**CITY OF BLOOMINGTON
PLAN COMMISSION AGENDA
Oct. 6, 2014 @ 5:30 p.m.**

**BLOOMINGTON PLAN COMMISSION
STAFF REPORT
Location: 700–730 N. Walnut Street**

**CASE #: SP-17-14
DATE: October 6, 2014**

Original Elevation

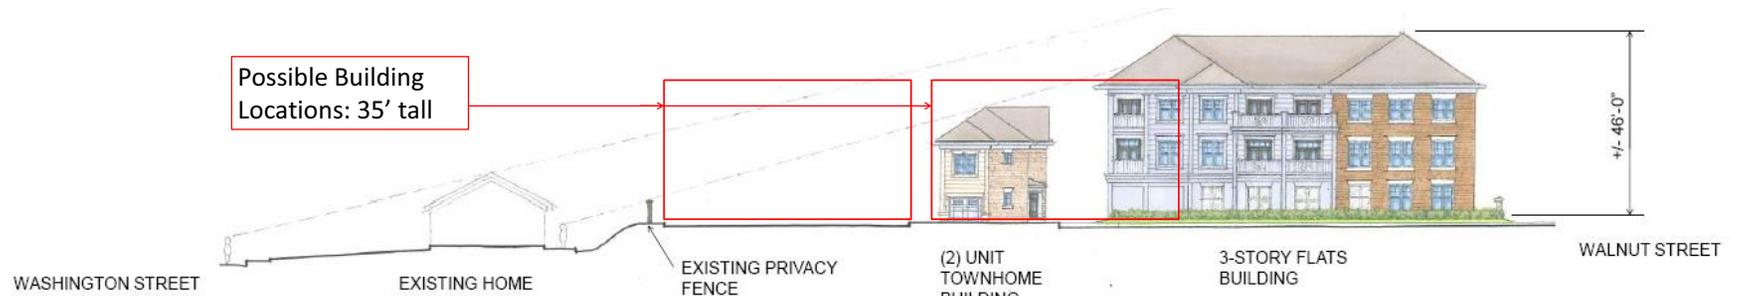
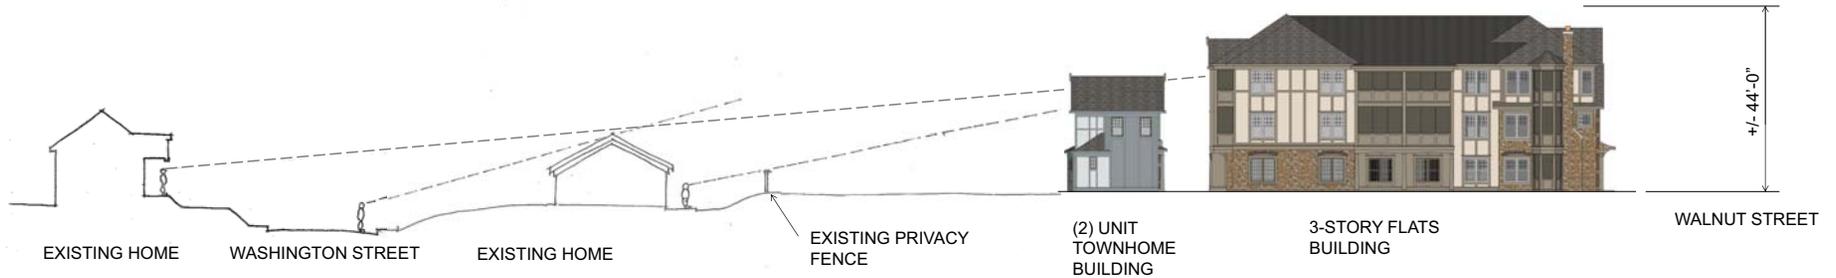
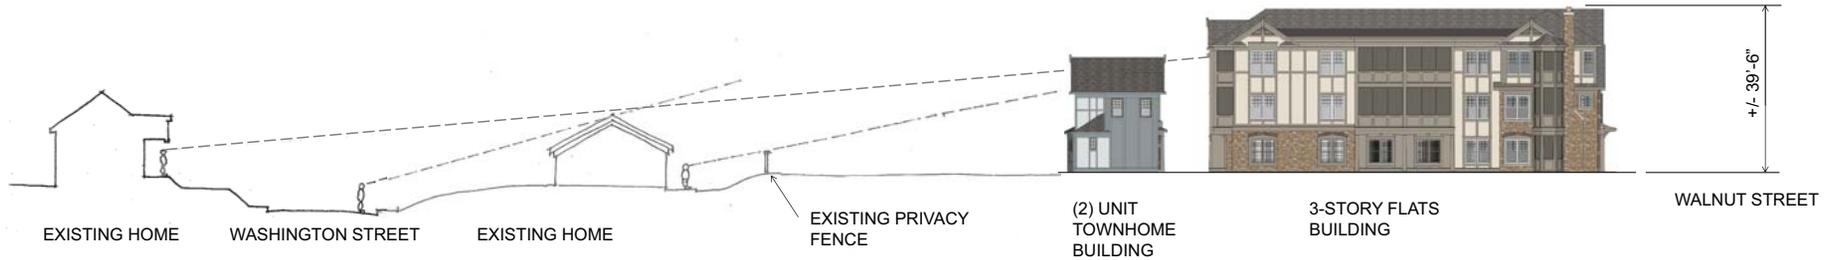
This project was heard in July of this year and was continued to a second hearing. The Plan Commission gave the petitioner guidance to reduce the overall height of the structures and to create a new shadow study that better represents the visual impacts to the High Point Neighborhood.

Height: The DEO district specifies a maximum structure height of 35 feet. The proposed 3-story structures had originally ranged in height from 44-48.5 feet due to the grade change across the property. The townhouse structure is 29.5 feet in height and complies with this standard. Although much of this overlay requires a pitched roof, this property lies along Walnut Street which would allow for either a flat or pitched roof. The petitioner has expressed that the intent of this waiver request is to allow a smaller building footprint that

The petitioner has revised the two larger structures in three ways to reduce height:

The petitioner has revised the architecture of the two larger buildings to reduce their overall height. The shadow study has also been revised with new perspective drawings of the revised buildings in context with the surrounding properties. The southern building has also had the finished floor lowered by two feet to minimize the visual impact of the proposed structure. While the building rooflines have changed to achieve these reductions, the architectural style and site plan have remained relatively unchanged.

SP/UV-34-13
Elevation

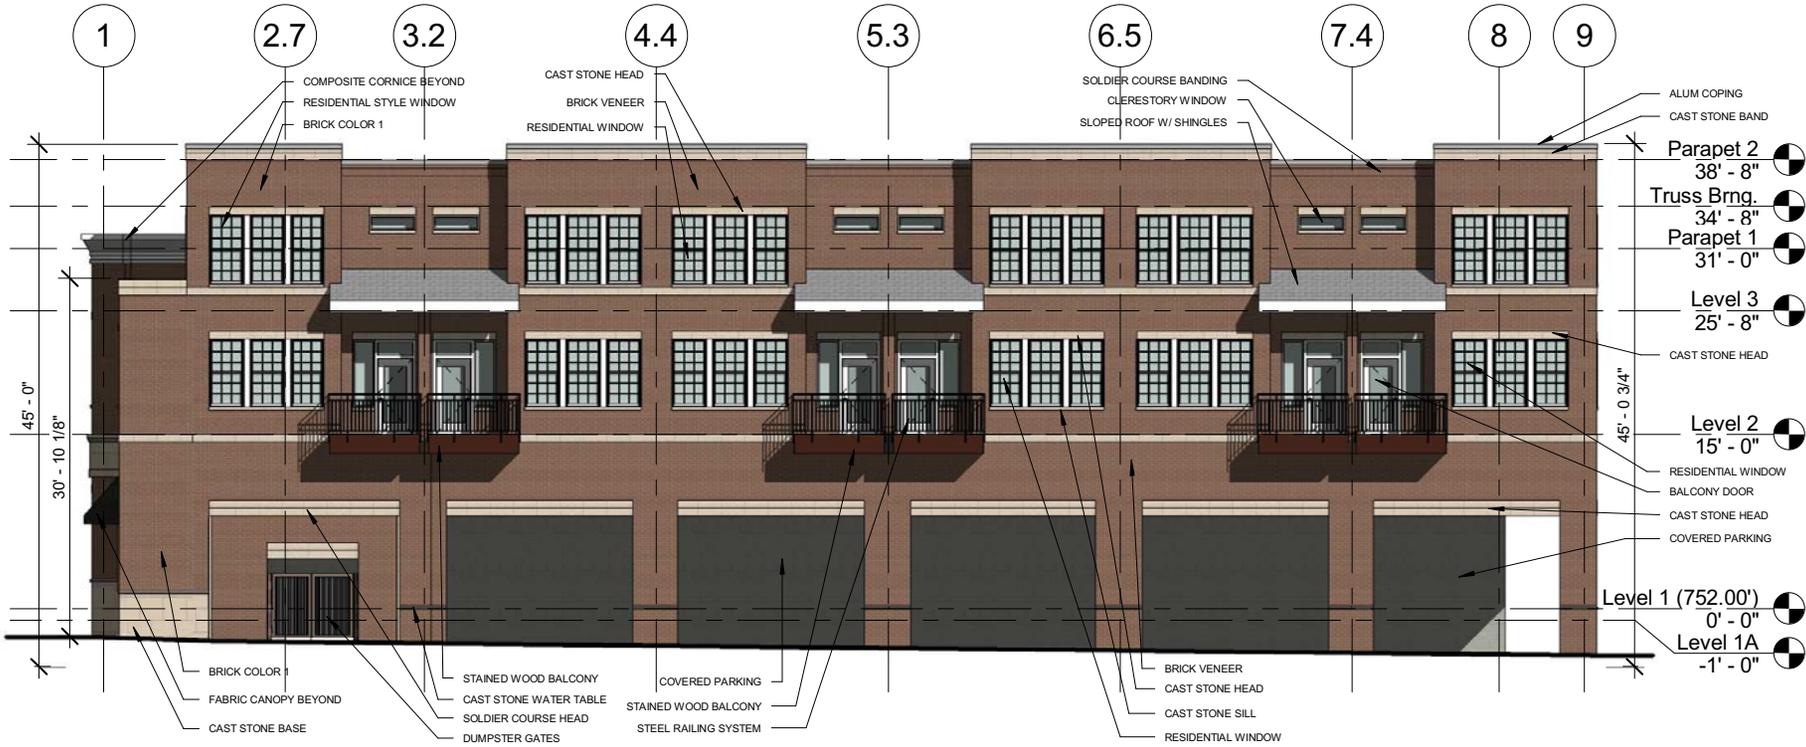
Void-to-Solid Ratio: The ordinance requires a 60% ratio on the first floor and 20% for upper floors. The proposal complies with the upper floor standard, but does not comply with the ground floor standard. Fifty percent (50%) is proposed along Kirkwood and 49% is proposed along Lincoln Street. This requires waiver approval from the Plan Commission. The original building proposal complied with the 60% requirement, but there has been no reduction in the actual amount of building voids on either street. The reason the percentage has dropped is that the first floor height has been raised to create a tall 2-story building appearance on Kirkwood. While not strictly complying with the void-to-solid standard, the proposed building does incorporate ample amounts of void openings along both street frontages.

Materials: The proposed building contains a combination of two colors of brick and a man made "cast stone." Both are permitted materials. One Plan Commissioner has expressed concern that the brick color proposed is not vibrant enough. This concern has been relayed to the petitioner. The stepped back third floor of the building also utilizes cementitious siding. This is not a permitted material, and staff has requested that this material be changed to a permitted material.
